ADDENDUM NO. TWO **REV.**  
WARREN WOODS PUBLIC SCHOOLS  
TOWER HS-TITAN EXPRESS SERVERY  
HAWTHORN FOOD PROGRAM FREEZER REPL.  
Page 1 of 1 (write up only)

March 24, 2025

ADDENDUM NO. 02 to the plans and specifications for the WARREN WOODS SCHOOL DISTRICT, TOWER HS – TITAN EXPRESS SERVERY-HAWTHORN FOOD PROGRAM FREEZER REPLACEMENT, Warren, MI, Architect's Project No. 242030, dated March 11, 2025

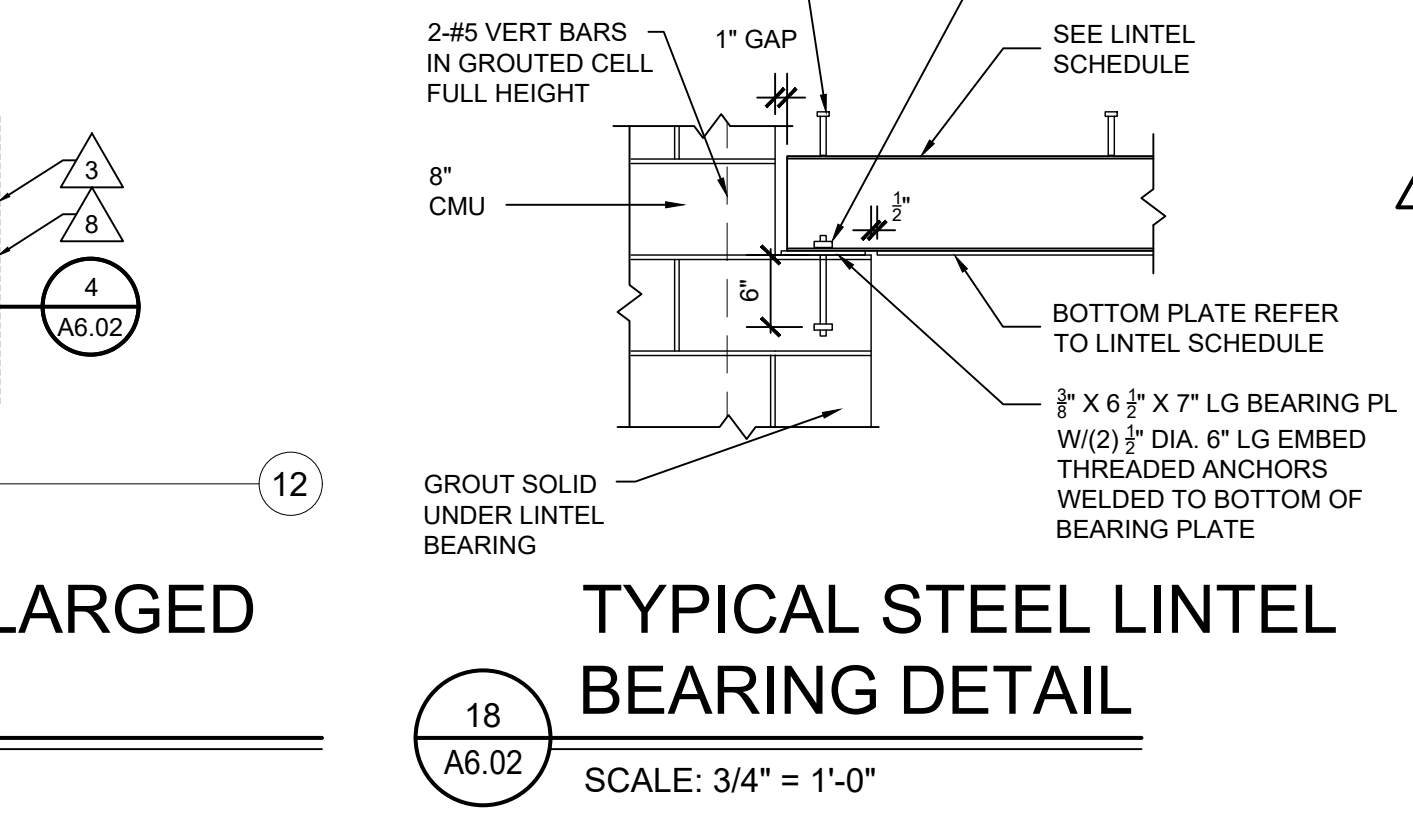
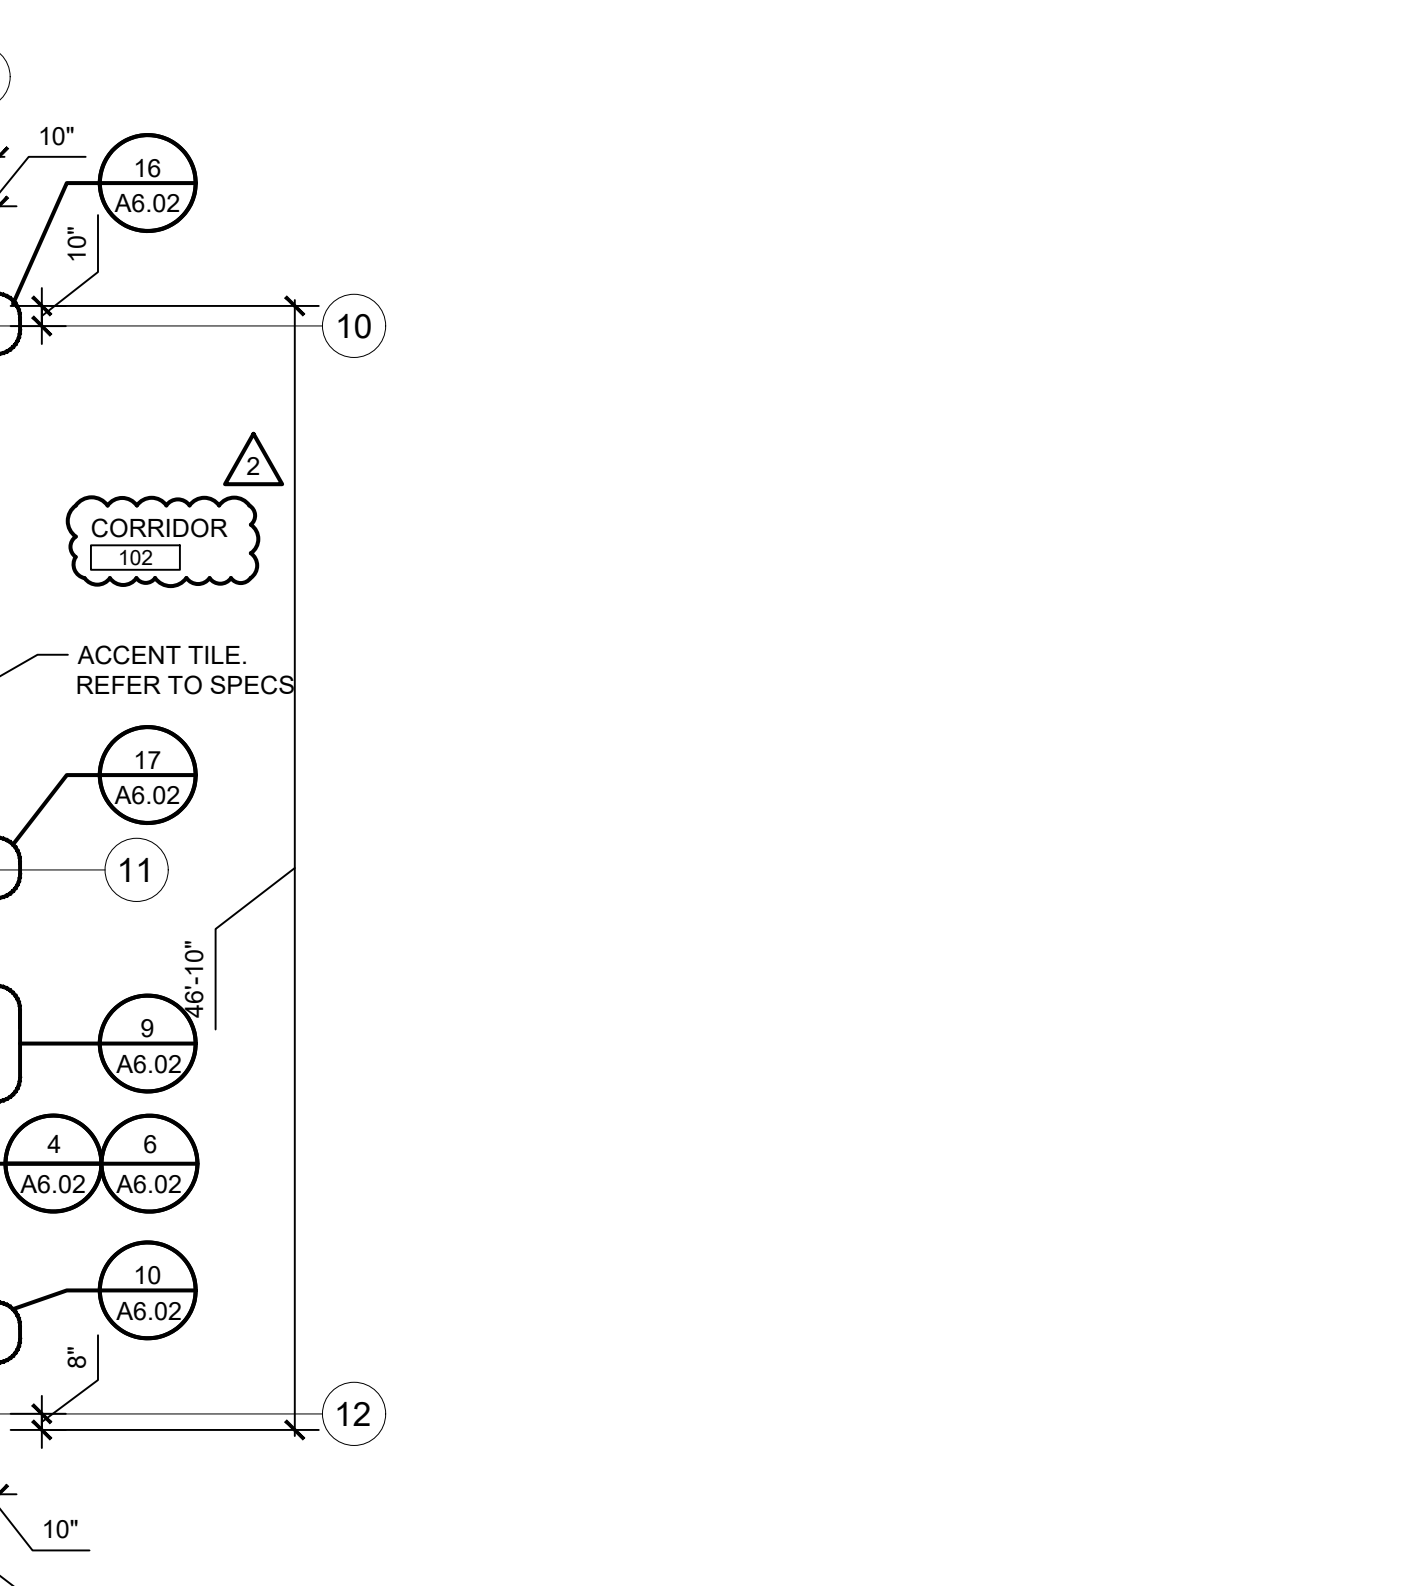
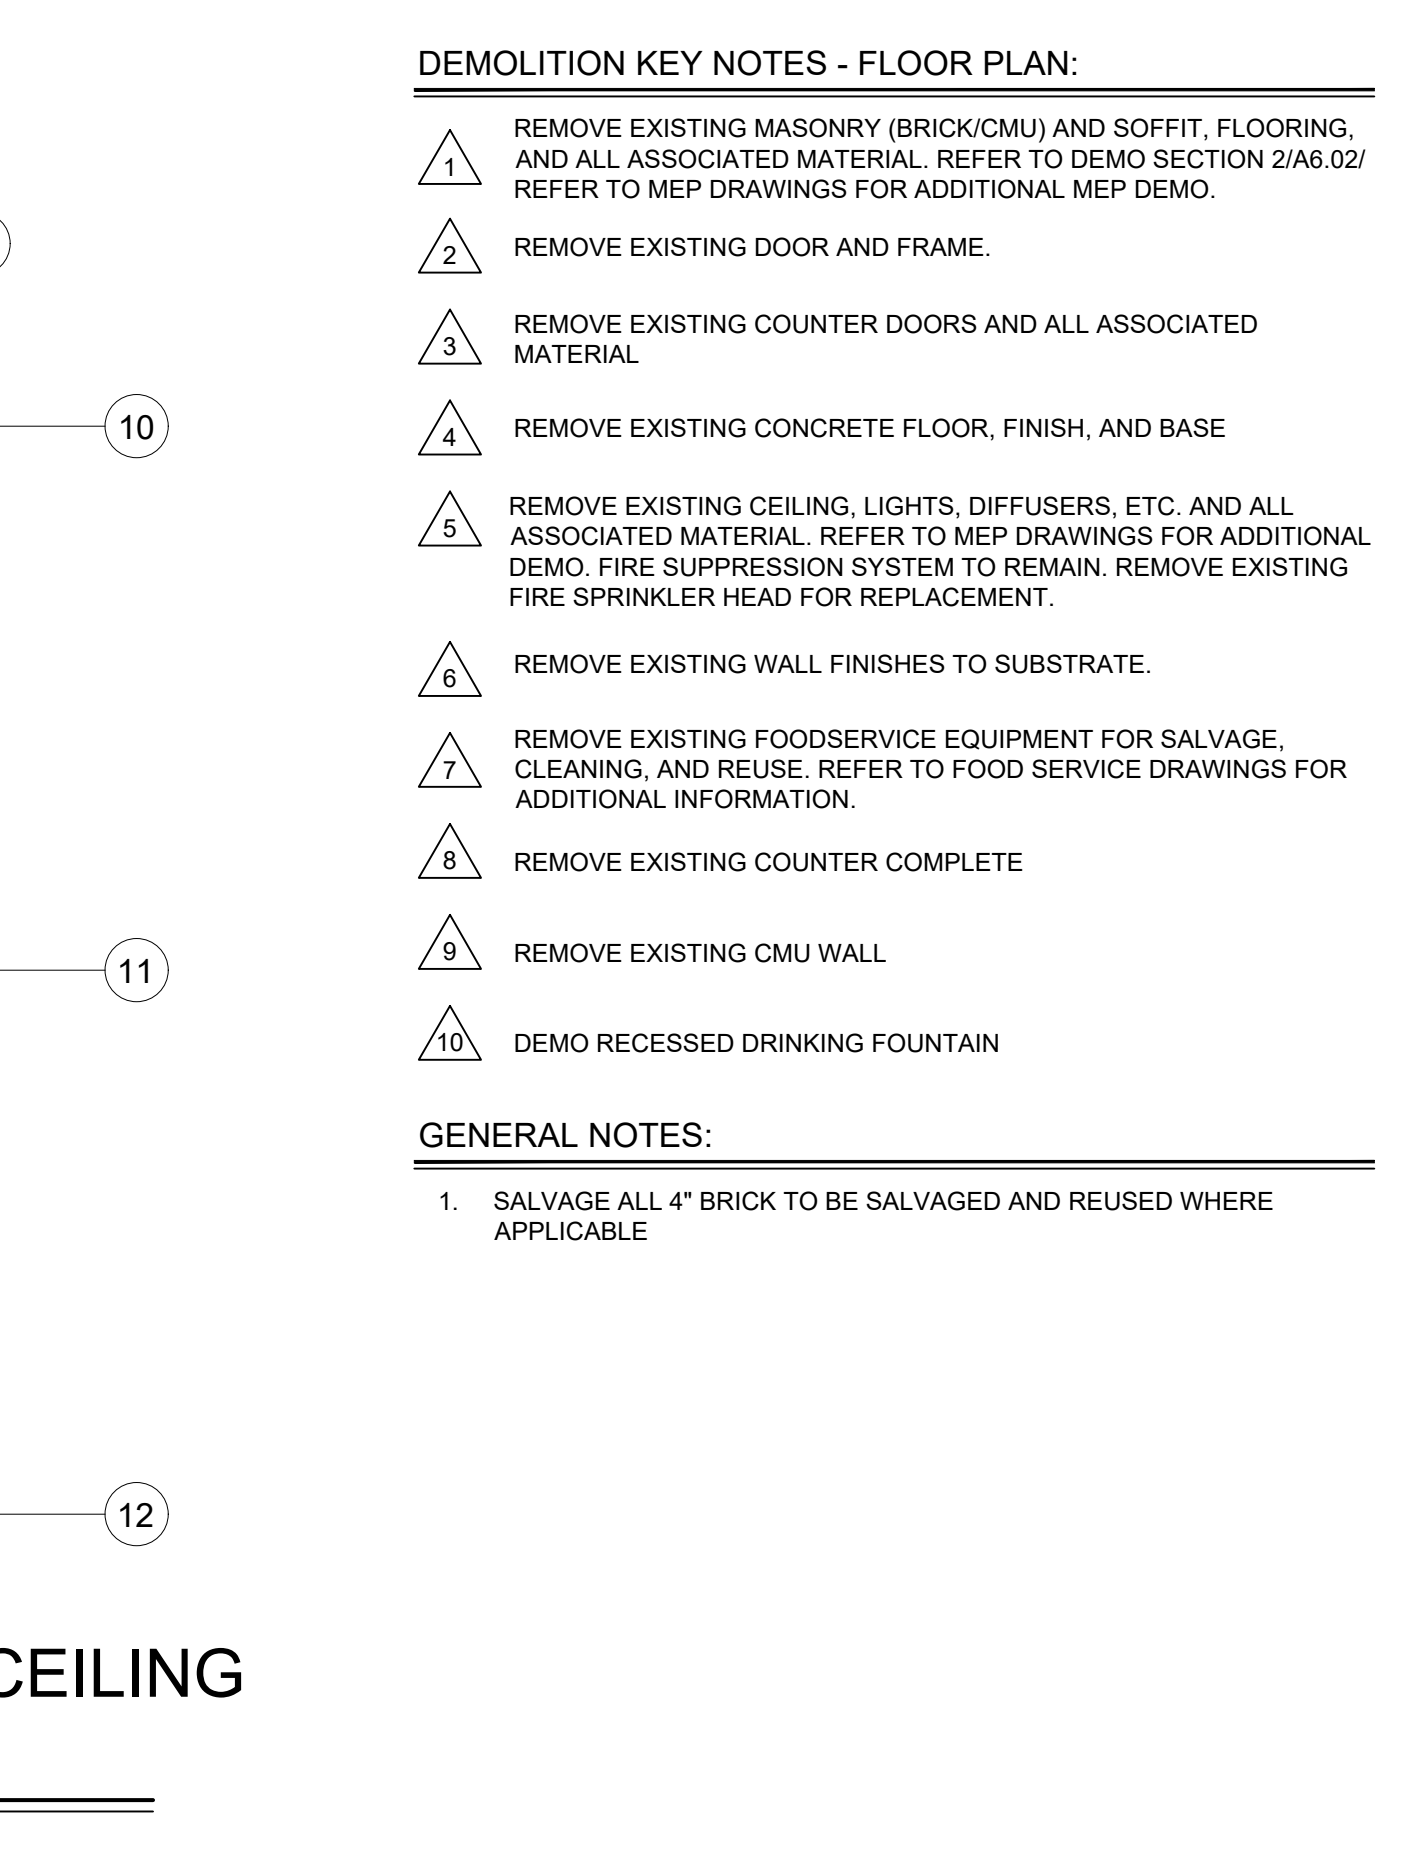
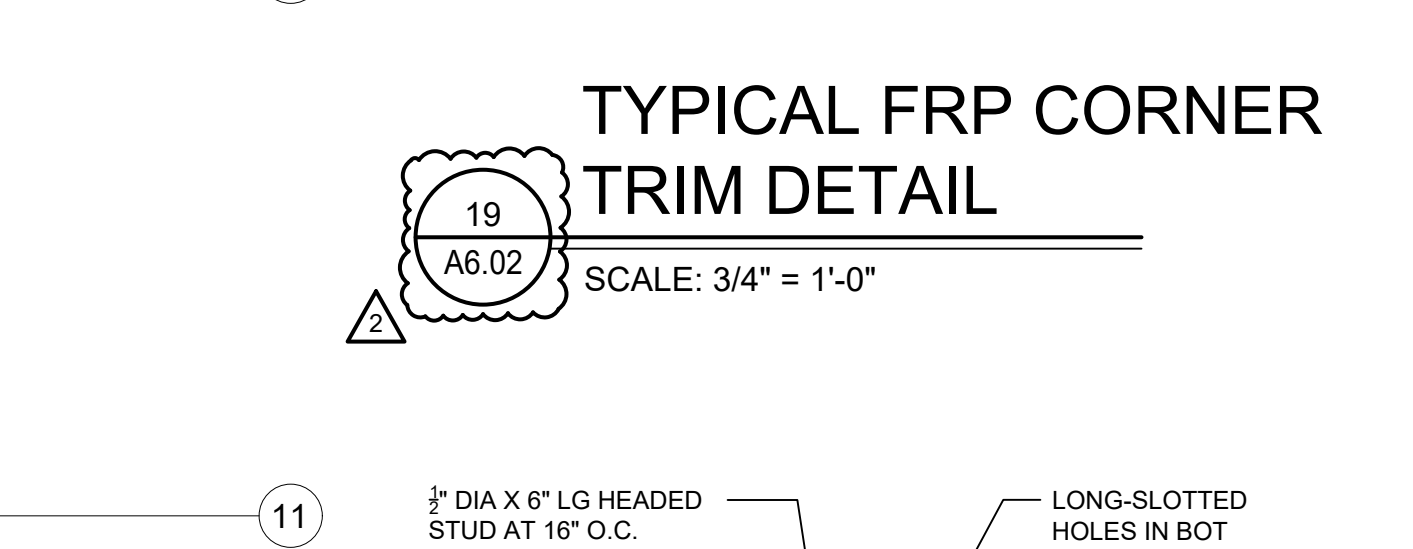
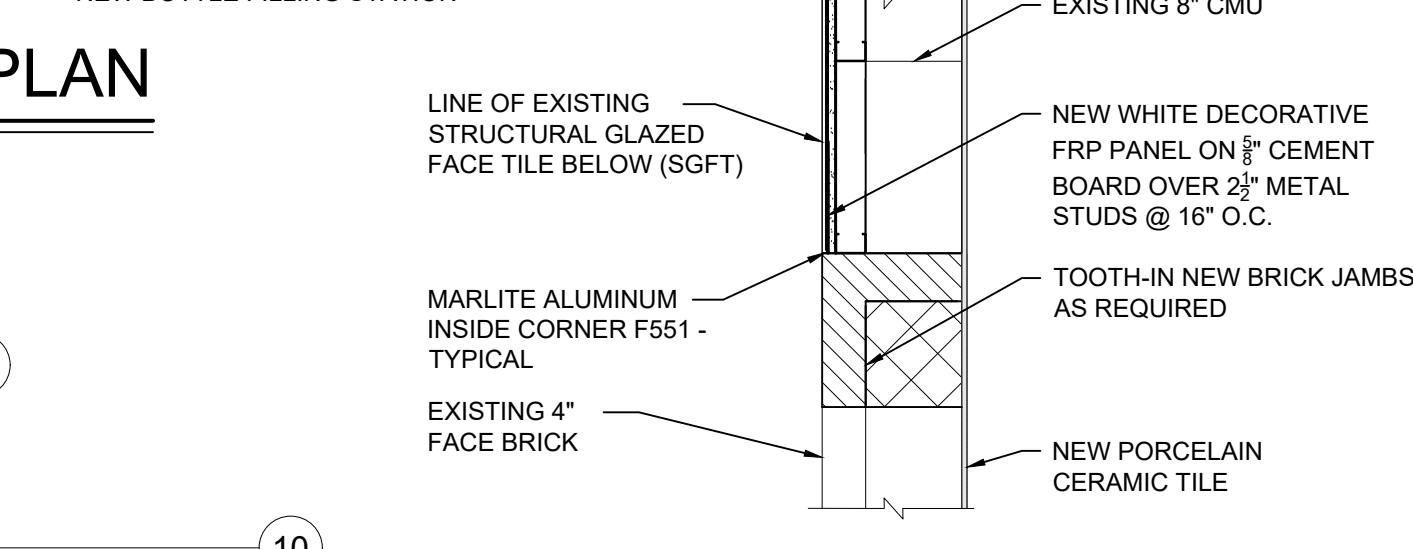
- ITEM NO. A1:** Refer to revised Sheet A6.02 (issued):
1. Added room names on enlarged Plan 2.
  2. Revised Detail 4 indicating to remove and salvage existing brick.
    - a. Clarified room names.
  3. Revised Detail 8 to show new FRP panel and associated backup, revise Spec Section 09772 to match trim and Spec Section 09280, change backup from 1-1/2" rigid furring to 2-1/2" metal studs @ 16" o.c. as shown on revised Detail.
  4. Added Detail 19 showing corner trim at new FRP panel.

**1 INTERIOR ELEVATION**  
A6.02 SCALE: 1/4"=1'-0"

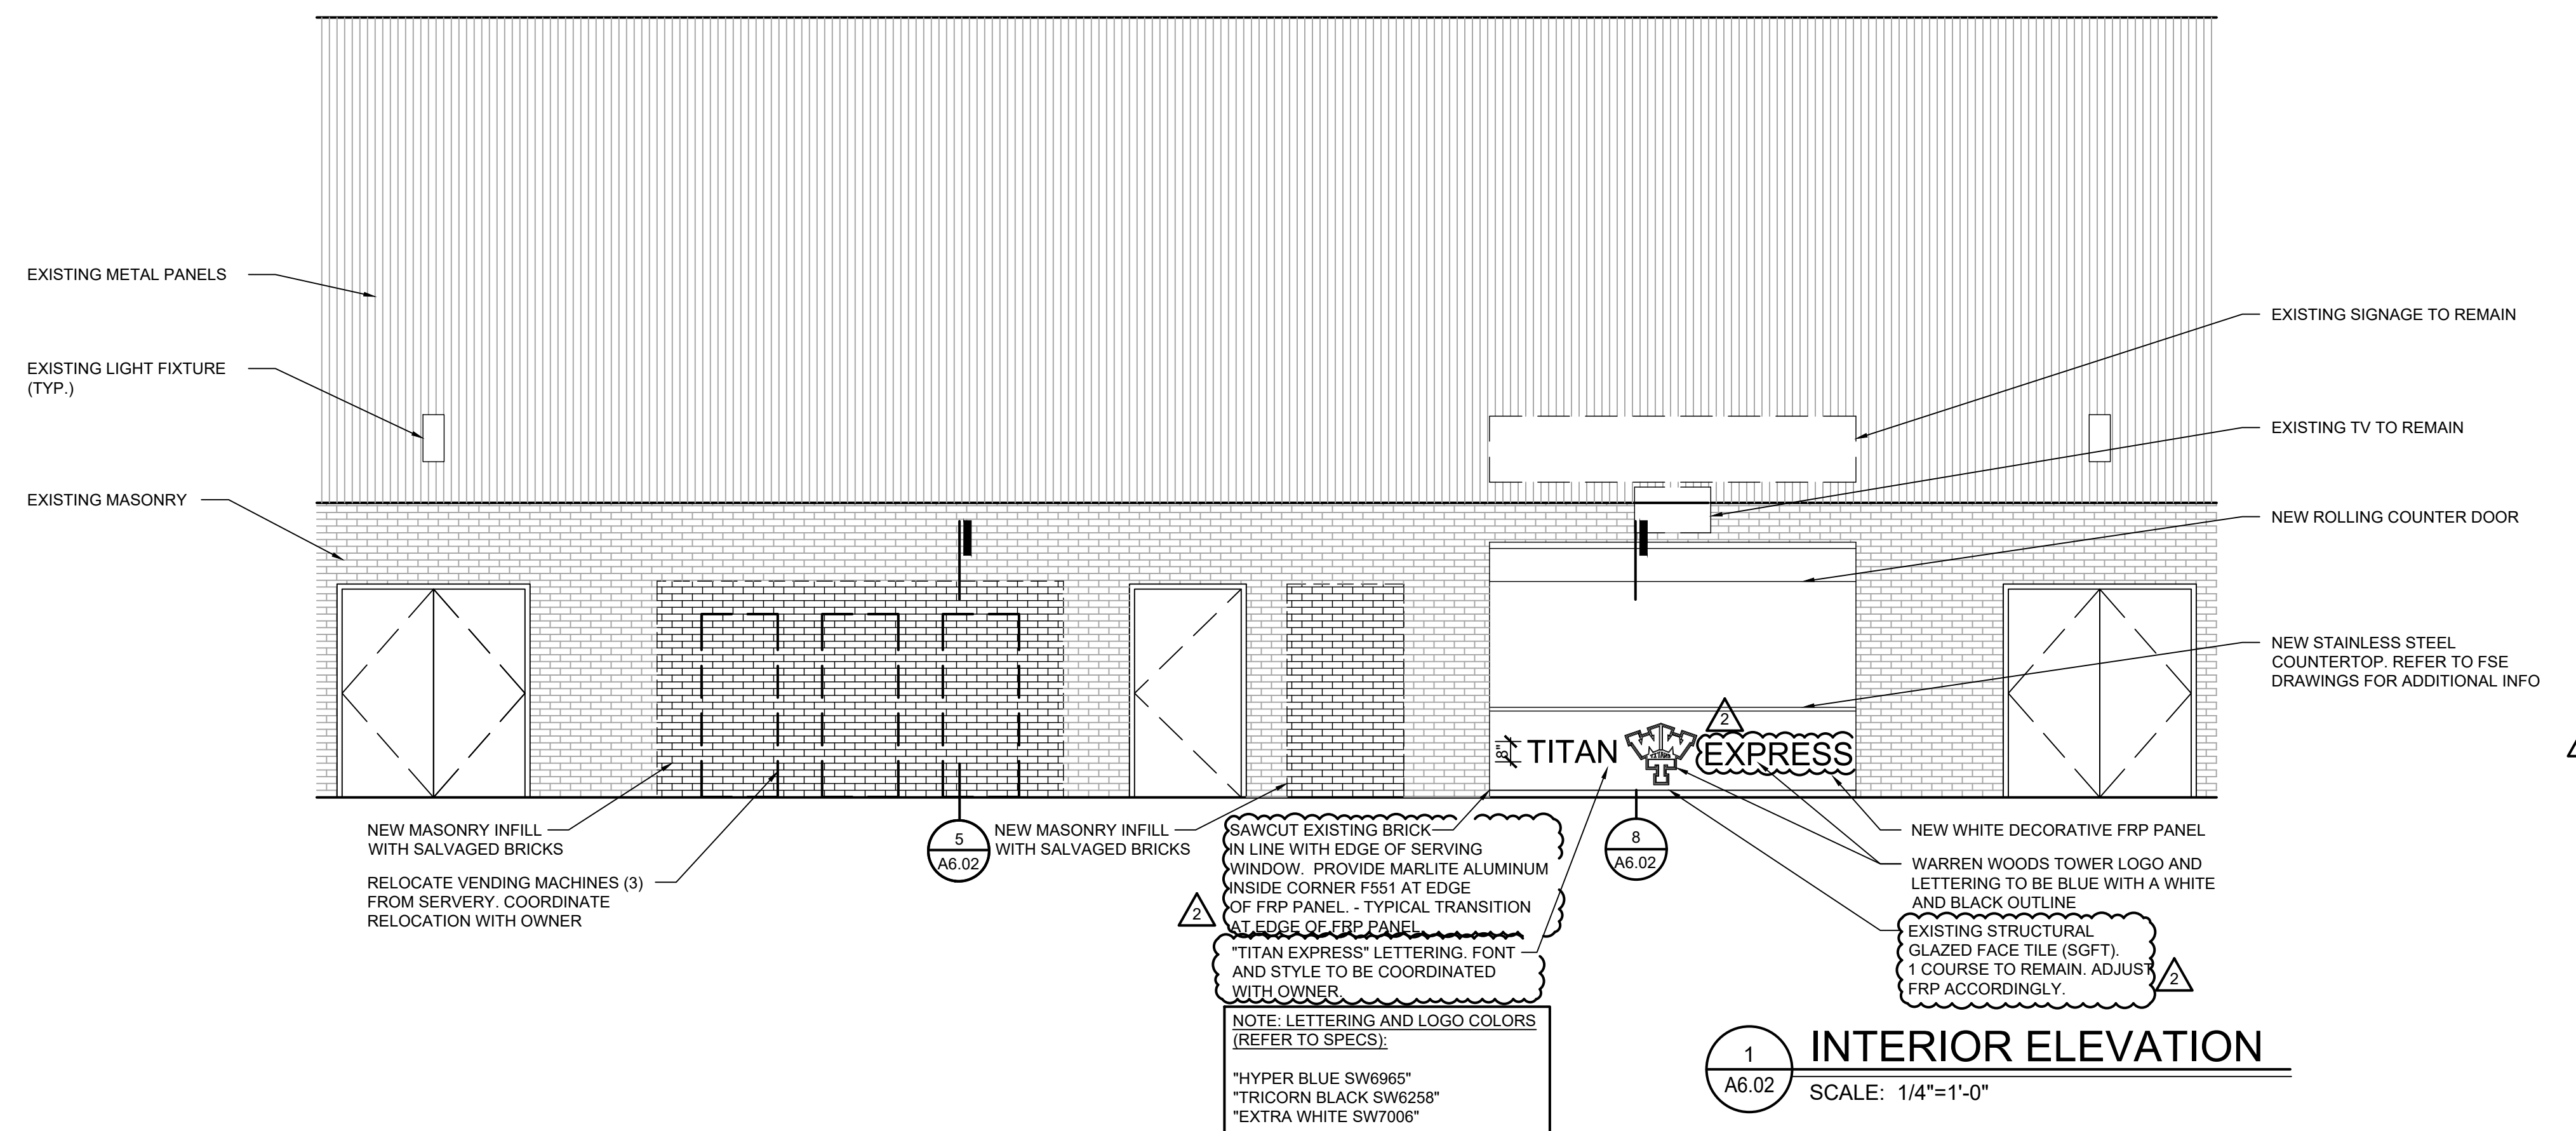
- ITEM NO. A2:** Refer to revised Sheet A6.03 (issued):
1. Modified interior elev. 1 showing new FRP panel.
